Application by Vattenfall Wind Power Limited for an Order Granting Development Consent for the Thanet Extension Offshore Wind Farm

COMMENTS ON THE APPLICANT'S DEADLINE 5 SUBMISSIONS

RAMAC HOLDINGS (TRADING) LTD - RICHBOROUGH PORT

ASSESSMENT OF VATTENFALL PROPOSALS FOR THANET OFFSHORE WIND FARM

Figure 1 – Extracted Figure 1.15

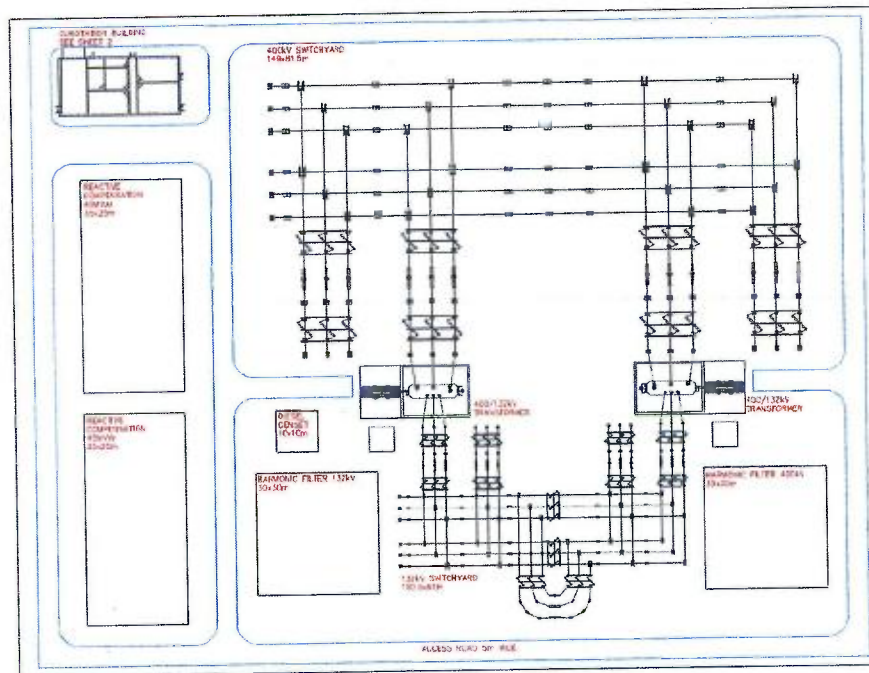
Vattenfall in their documentation have identified a substation area of 215m x 160m (c.8.6 acres) as advised in Table 1.3 of Volume 3, Chapter 1 of their Preliminary Environmental Information Report. Below, in figure 1, is an extract from the same document noted as Figure 1.15 and is titled as an “Indicative Layout of the Onshore Substation”.

The questions that arise regarding the physical size of the substation are:

- i) Why has it been assumed that all of the substation components are to be installed on a single level in an open compound, which has the greatest footprint.
- ii) What is the basis of the decision to select AIS (air insulated) switchgear in lieu of GIS (gas insulated) switchgear, given that the latter has less of a footprint.

Figure 2a – Multi Storey GIS Building Arrangement – Layout

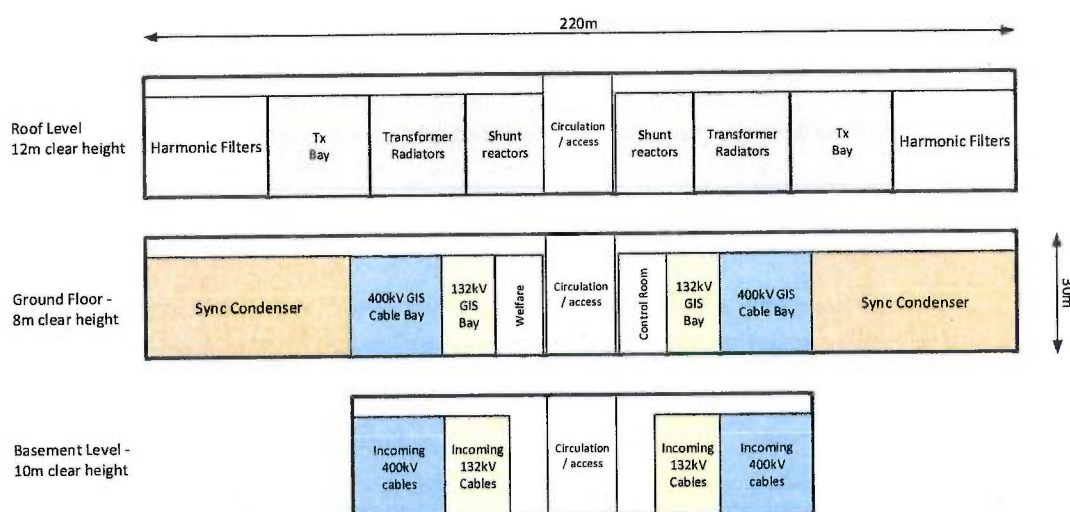
In our initial assessments, I considered a multi-storey building arrangement which would have reduced the overall footprint from 8.5 acres to circa 2.3 acres; with the additional information provided in Annex B to Appendix 1 to Deadline 5 Submission. It is accepted, in the light of information now submitted, that this may not be achieved to quite that level, nonetheless, it is possible to achieve a significant reduction in the overall footprint required.

In Figures 2a and 2b below, are shown schematic arrangements of how the components noted in Table 2 might be arranged to reduce the footprint; note that all of the components that would have to have “outdoor” access to air and craneage are on the upper level, all other components are on the lower level including all the switchgear which is assumed to now be GIS.

The arrangements shown in Figures 2a and 2b ensure that equipment requiring external access to air and access are provided and allowances for blast and fire walls provided within the structure; given this, all of Vattenfall's primary reasons for having an open compound are shown to have been dealt with within a multi-storey building with a significantly smaller footprint.

The schematic arrangement in Figures 2a and 2b can then be compared in terms of footprint area as follows:

- II. **Alternative proposal (GIS based in a building, see illustration below in Figures 2a/2b)**
Building footprint required = 220m x 30m = 6,600sq.m
Total Site Footprint required = approx. 12,000sq.m or 3 acres
(includes 10m area around building)
Maximum height = 20m
Basement = 10m

From the high-level assessment above, it can be seen that there is vast difference in the site footprint required between the two options, even allowing for a 10m fence all around, the site footprint would only be around 35% of the Vattenfall proposal. It is therefore suggested that Vattenfall could and should seriously consider and adopt this option in terms of layout.

Figure 4 – MOJ Replacement Land Substation Assessment

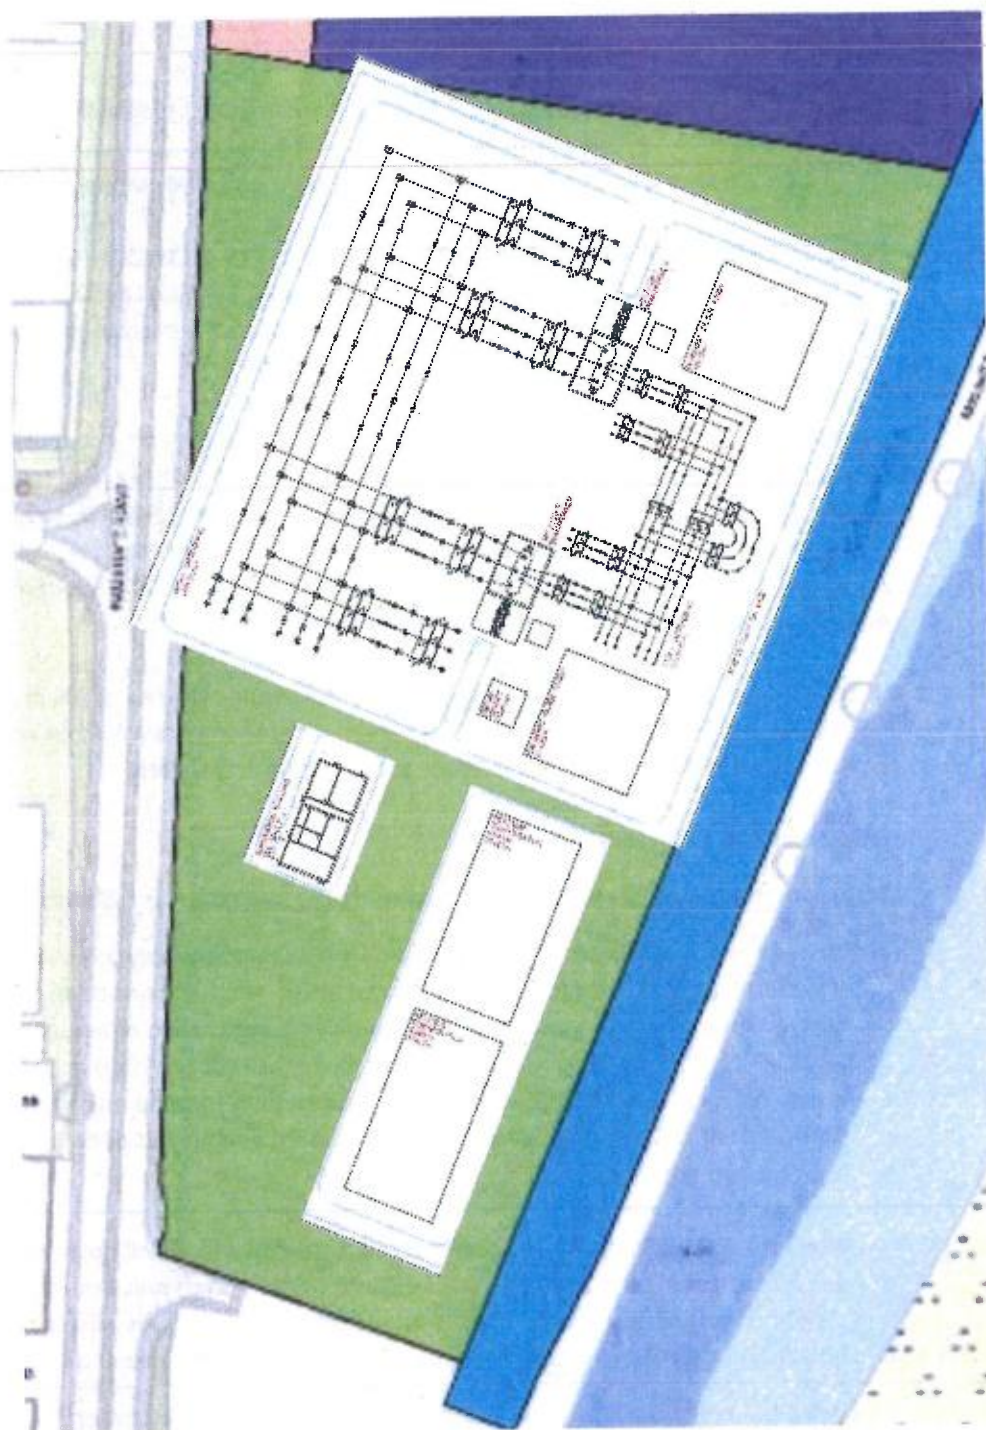
Using the land arrangement shown in Figure 3 above, an assessment has been made to see how the components of Vattenfall’s proposed AIS substation could be fitted within the site boundary. Figure 4 shows this assessment; it is fairly crude, but it does show that with some reasonable additional design input to the arrangement that the substation could be fitted

within this site. It has been deliberately shown in the northern part of the site for two reasons:

- 1) To give the greatest noise reduction to the nearest residence (see more below)
- 2) To minimise the cabling route length to the site (see commentary below).

Figure 5 – MOJ Replacement Land - Alternative Substation Layout

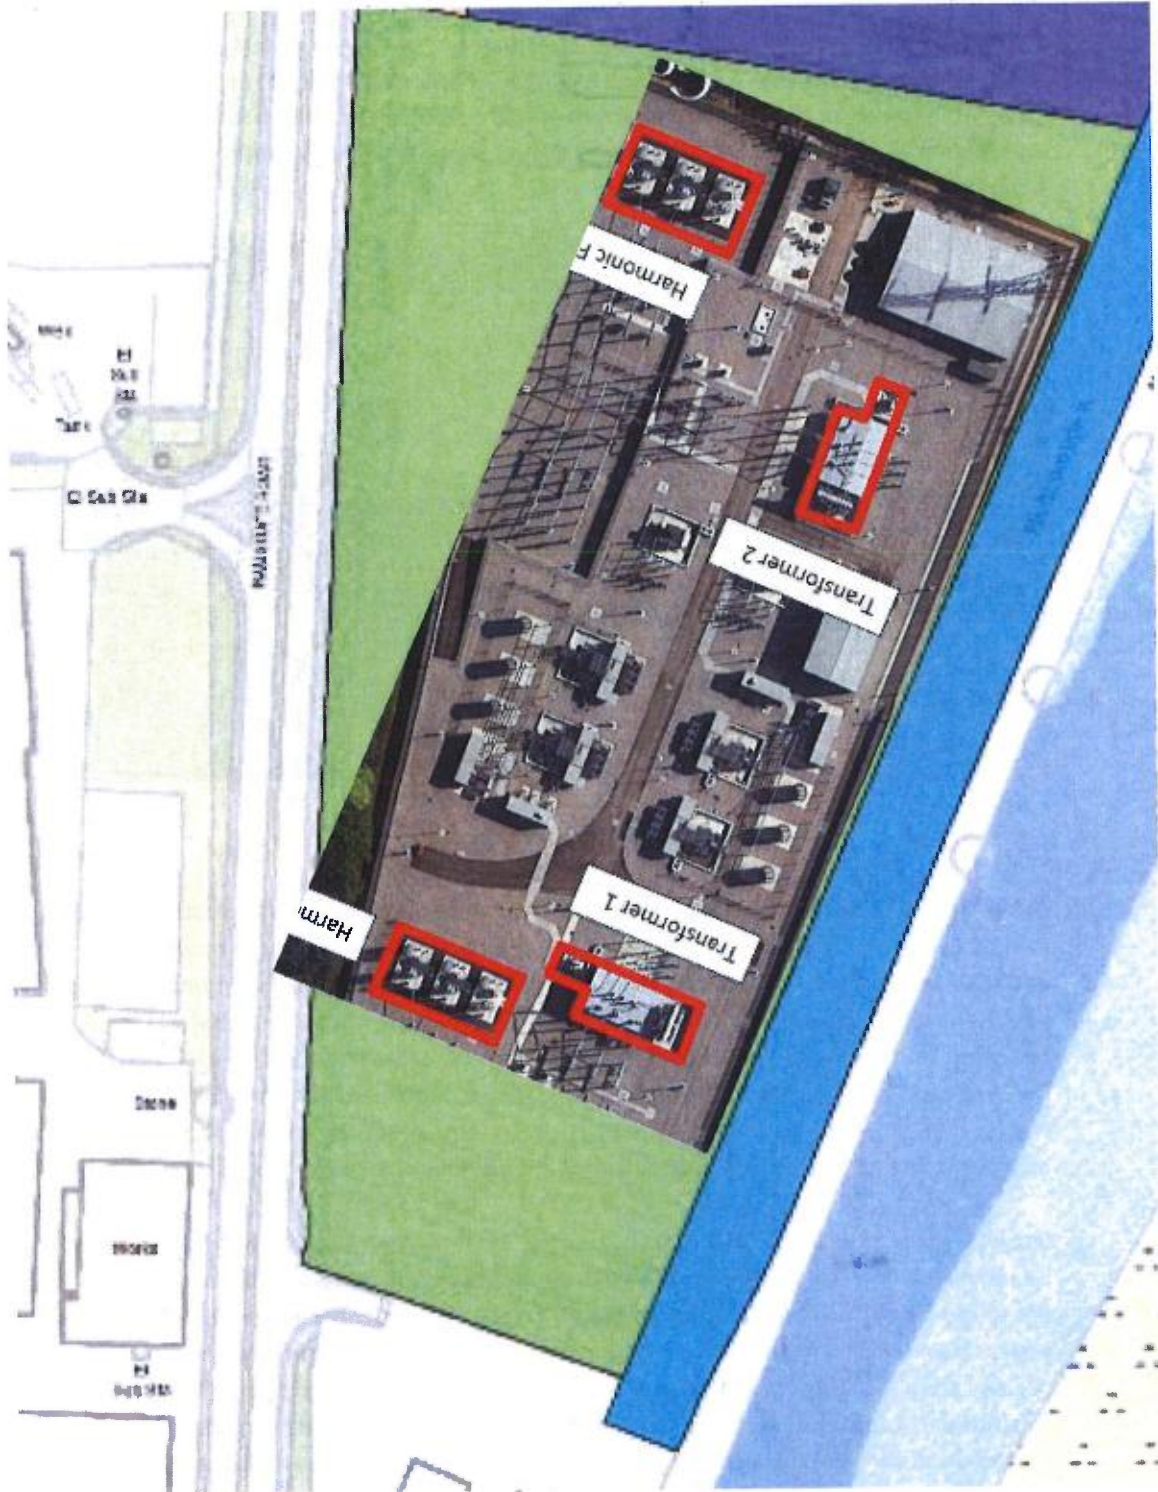
Vattenfall, in its latest submission in Annex B to Appendix 1 to Deadline 5, have in Section 2.3, Figure 1, including an example Onshore Windfarm Substation Layout. This is very useful, firstly because it demonstrates that other less square arrangements are possible, secondly because the area required appears to be reduced.

We have taken this Google Earth image and re-scaled it and applied it to the MOD replacement land, as shown in Figure 5. We have estimated that the area taken is circa 120m x 250m giving an overall area footprint of 30,000sq.m or 7.5 acres, so around 12% smaller than the footprint that Vattenfall are currently claiming. However what is as important, as shown in Figure 5 is that it fits very well with the MOD replacement land; the question arises as to why this hasn't been considered by Vattenfall?

In addition, the arrangements in Figures 4 and 5 still assume the use of AIS in a single level open compound; if GIS was used then the footprint requirements would be reduced significantly and there would be no issues at all locating in this area.

Figure 6 – Stonar Cottage

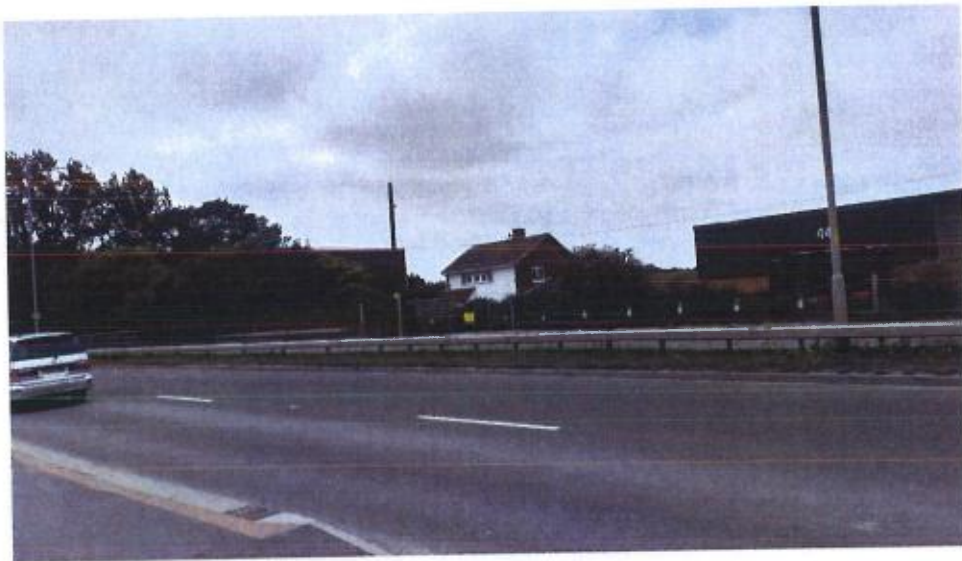
The nearest residence to the above site is Stonar Cottage, see photo below in Figure 6, which is estimated to be around 320m. Using the assessment process noted above, it is estimated that there would be an attenuation level of circa 42dB, therefore the reduction of noise emitted by plant will be $70\text{dB} - 42\text{dB} < 30\text{dB}$ and therefore be likely acceptable to the local authority. In any event, it would be possible to install attenuating elements to reduce noise and ensure that the chosen equipment keeps noise emissions to an acceptable level.

Figure 9 – Indicative trench arrangements for Sandwich Road
(extract from Volume 3, Chapter 1, Figure 1.14)

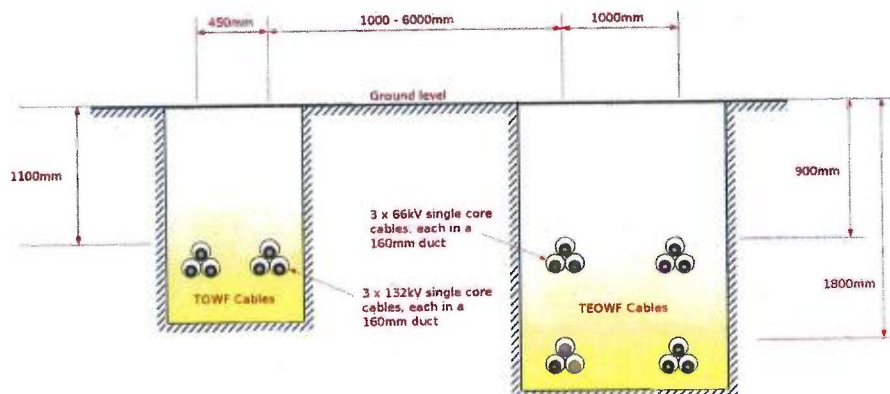
Vattenfall have advised that they have not yet decided as to whether the circuits from the offshore windfarm will be at 66kV or 132kV (the maximum voltage available to Vattenfall). Vattenfall have therefore shown two indicative versions of cable trenching for these two voltages as shown in Figure 9. The arrangements shown are typically for a DNO or IDNO distributing cables at these voltages. What is not defined are the limitations that will be applied to the land that they cross, such as the Bay Point Sports Club area; the norm is to run along public roads or footpaths. The limitations stem from (understandably) not interfering with the cables and the ability to access the cables should a fault arise. As such, no building structures, piling, concrete slabs should be built above these trenches as these will impede access. However, laying down of roads, car parks, gardens or walkways would be possible as these would still allow access.
